**Safety and Operational Study of Charles Town Pike (Route 9)
Blue Ridge and Catoctin Election Districts**

**Concept Alternatives Preference Survey
Summary of Responses
Fall 2021**

Alternative A

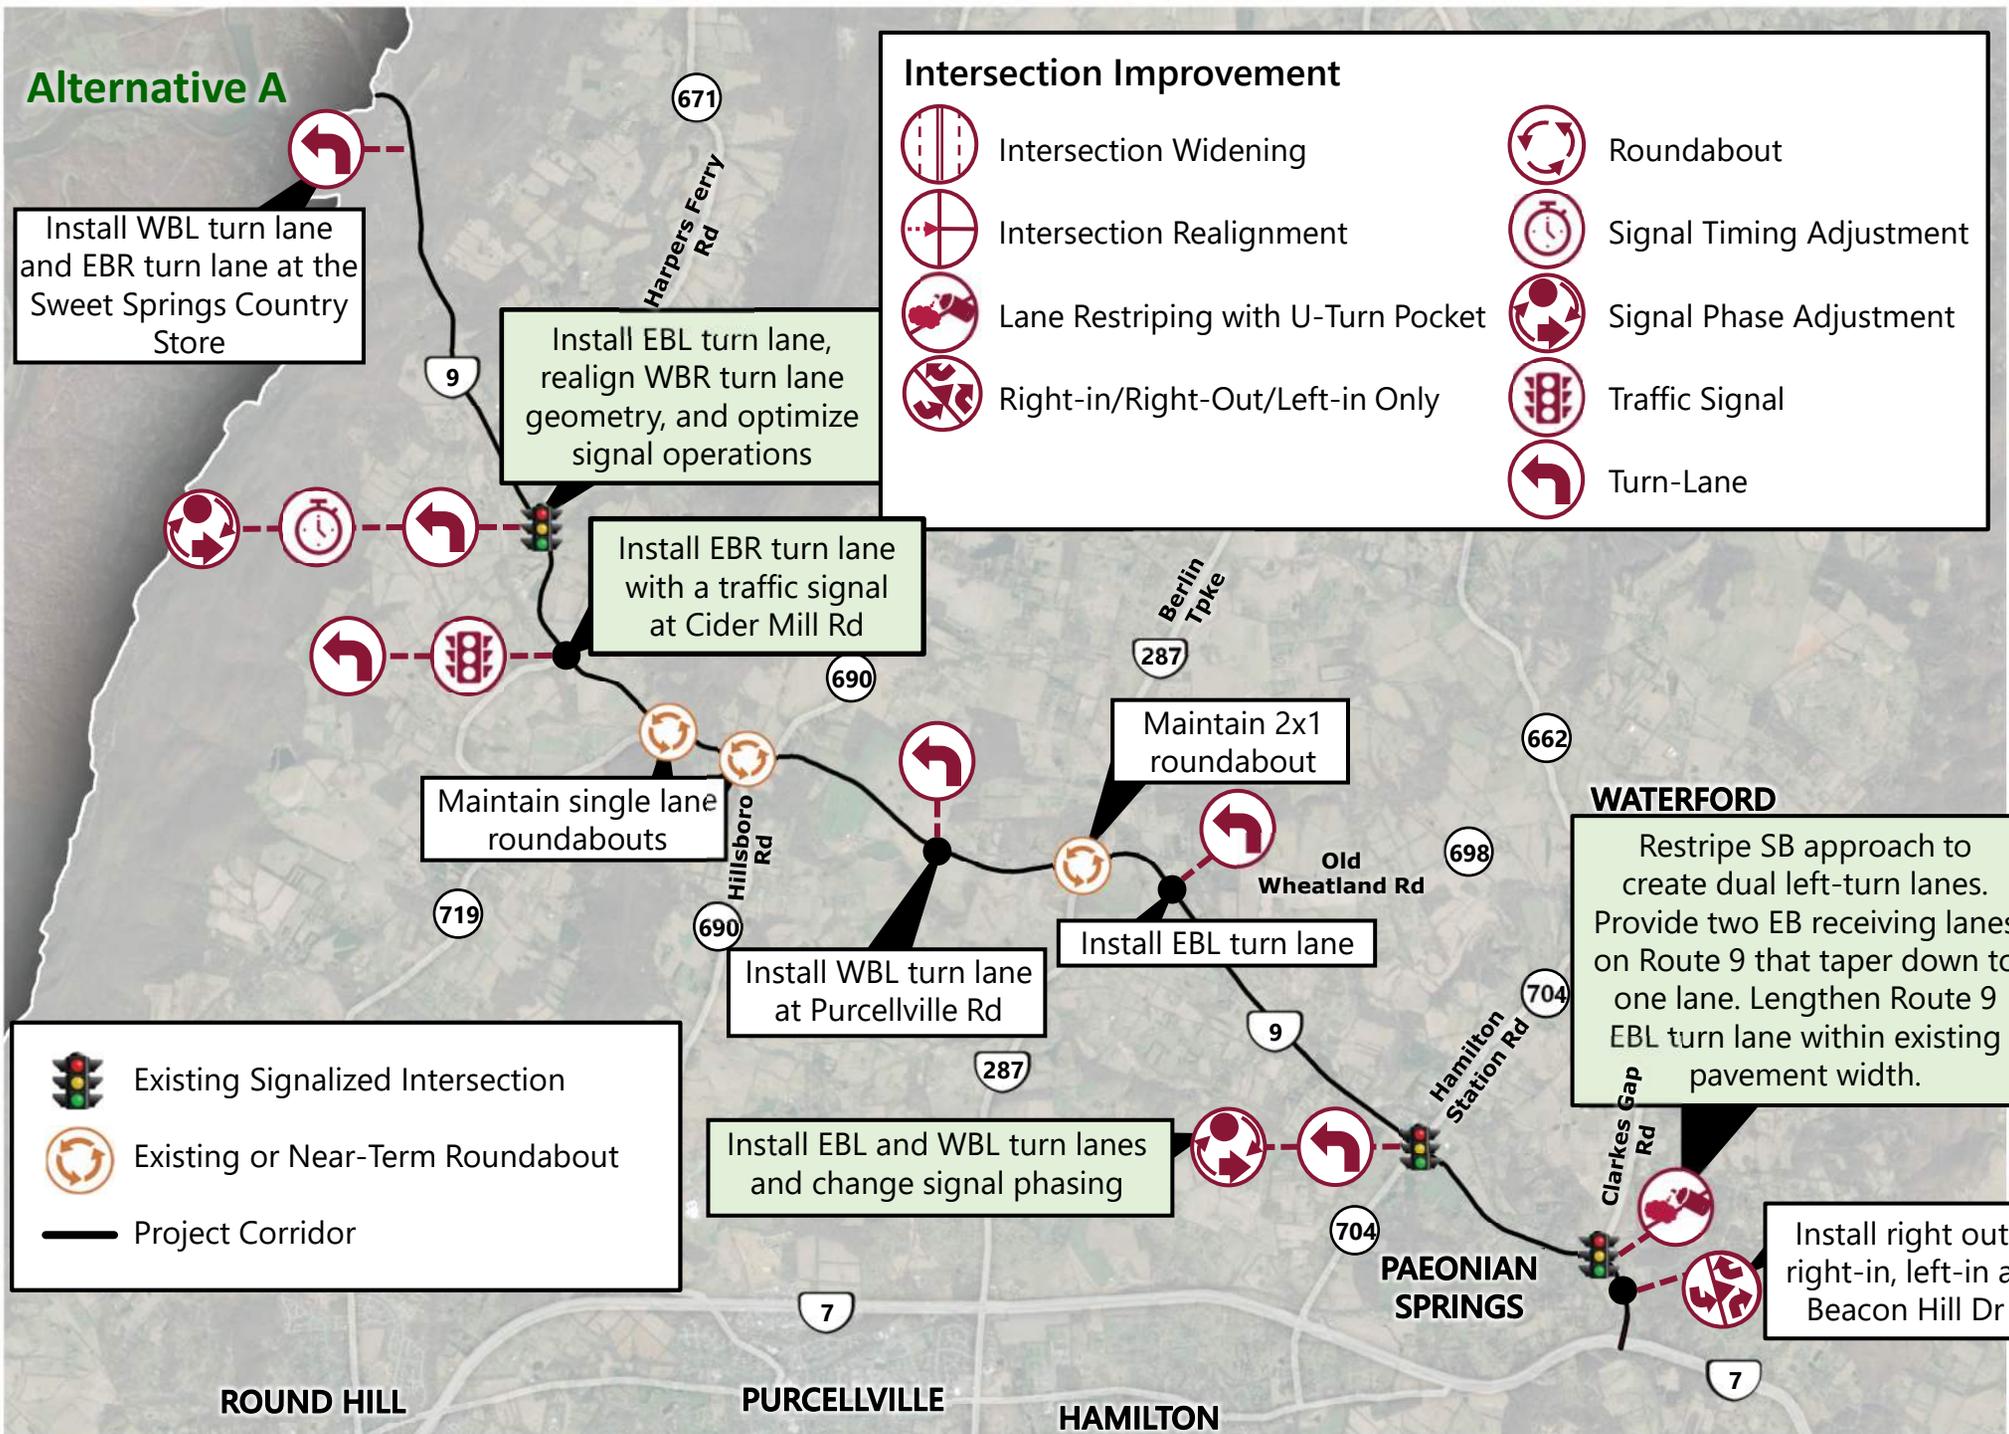
Comments for Alternative A
 Roundabout at Rte 9 and Harper's Ferry Road.

Comments for Alternative B
 I prefer the changes shown in Alternative A for Hillsboro and points west of Hillsboro.
 Better address known cut through on Gaver Mill Road. Better identify key issues for north-south routes impacted by Route 9 and other planned improvement projects (e.g., Route 7/690 interchange, Route 287/7 improvements, route 9/287 roundabout). All will impact "safety and operations" overall.
 The county could save money and increase safety by including a 24"-30" shoulder along Rt 9 (and other local roads as they're repaired/refinished) to include a bike/walking lane to accommodate the cyclists and walkers I already see out there during daily commutes (mostly afternoon) and on weekends. Rolling it into the construction already happening will minimize costs.
 Widen Route 9 from Route 7 to West Virginia – Decrease congestion, improve trade and access to rural businesses.
 The intersection needs a bridge to carry the traffic. Just like any other project, we will be back here in 10 years or less putting a bridge. Lovettsville and Purcellville are growing.

Shared Use Path Draft Recommendations

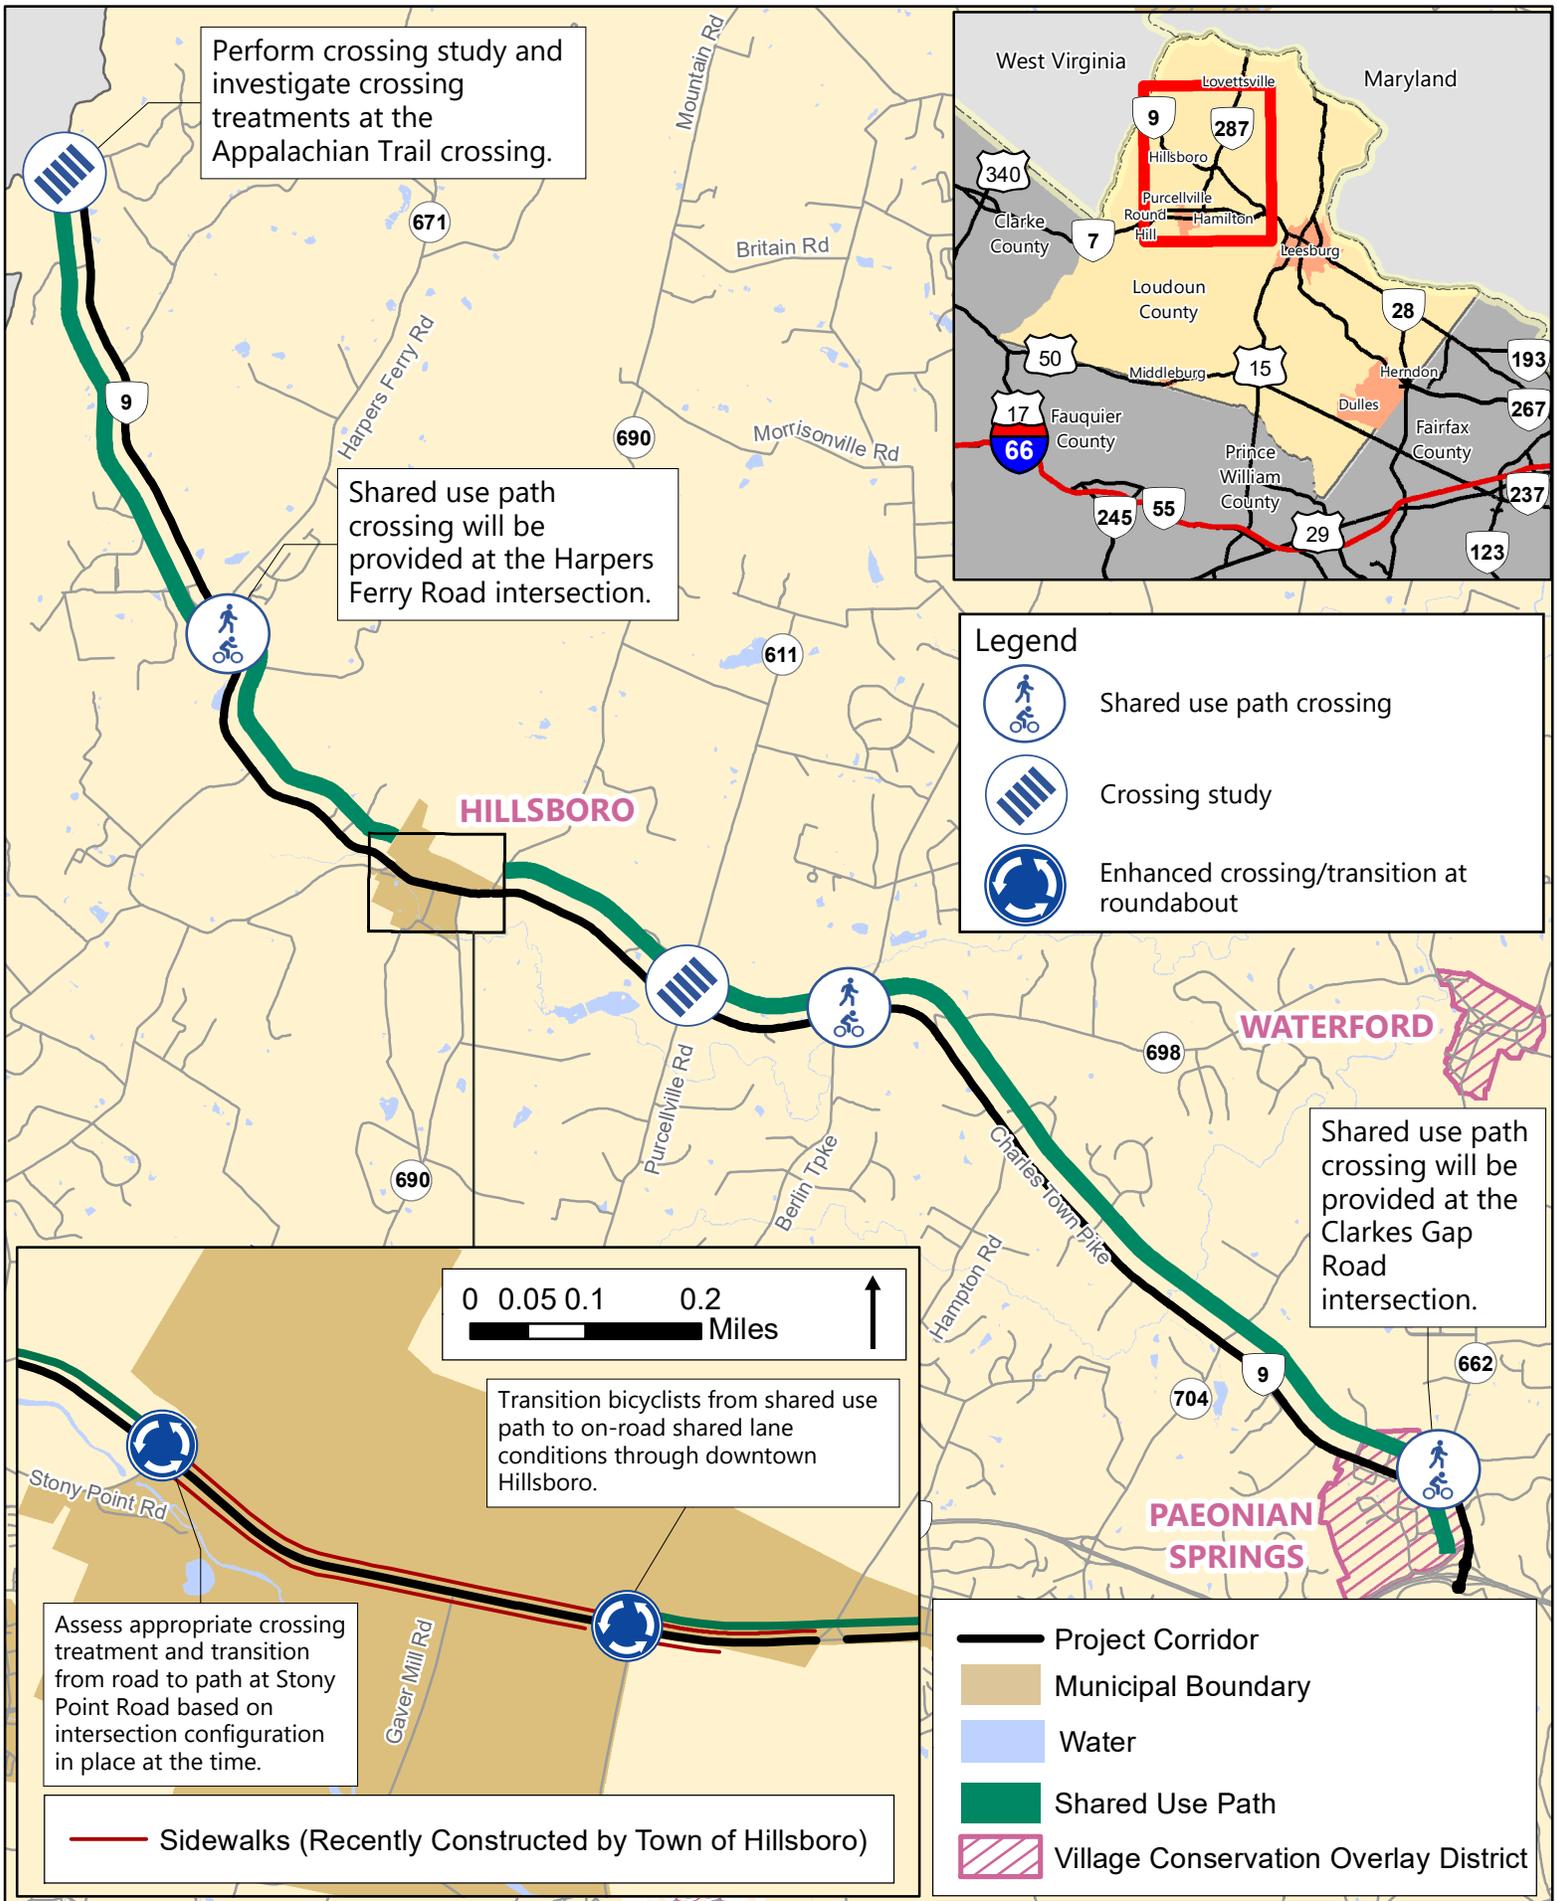
Comments for Part 2 – Suggested Modifications to Recommendations
<p>Numerous farm/ag/rural businesses are on the North side of route 9. AltaTerra Vineyard, Hillsborough Vineyard, Kalero vineyard from just past (east) intersection of Harpers Ferry to just before the descent down towards Hillsboro & Stony Point road. Even with the utilities buried underground, our vineyard turn radius corridors for our tractors would be compromised. A smaller vineyard would not be economically viable for AltaTerra Vineyard. Hillsborough Vineyard would also have to take vines to provide enough space for the tractor corridor inside their new relocated deer fence. Our property has a high berm along route 9 and a little road shoulder.</p>
<p>Harpers Ferry Road to town of Hillsboro</p>
<p>Between Harpers Ferry Road and the WV border</p>
<p>I think the shared use path should be on the north side for Rt. 9 between the Appalachian Trail Crossing and Harpers Ferry Road. One crossing treatment could be provided at Sweet Springs store. There are wineries/breweries on the north side of Rt. 9 on or near Sagle Road, which could lead to unsafe crossings.</p>

<p>I do not think there should be a shared use path because it would widen Rt 9 and require cutting down trees and cutting into the mountainside. If Loudoun decides to create a shared use path, it should all be on the North side of the road, from start to finish. It should not cross over and be on the South side of the road from Harper’s Ferry to West Virginia. This will lead it to the parking lot for the Appalachian Trail, where there will be a cross-walk.</p>
<p>I don’t think there should be a shared-use path from Harpers Ferry Rd to the WV border. Instead, make the path go up Harpers Ferry Rd to Loudoun Hts and the Potomac River. It’s a far more scenic and less intrusive place for a pathway. If the path is going to continue form Harpers Ferry Rd to the WV border, then it should be on the north side of Rt 9. Putting it on the south side of Rt 9 would dramatically and negatively impact the rugged beauty of the area as Rt 9 passes through the Ridge.</p>

<p>From Hillsboro to Berlin turnpike the path should be on the Southbound side of the road. This would allow for people easy access to cut thru the subdivision at Daily farm Lane which will eventually be tied into the path that is being built in the new subdivisions off rt. 287 and also allow for easy access to Purcellville road into Purcellville from the people traveling westbound. Second, it will be easier for people coming off the WD&O using Purcellville rd easier access into Hillsboro. Third visually the line of site for walkers and bikers is much better from the southbound side of the road.</p>
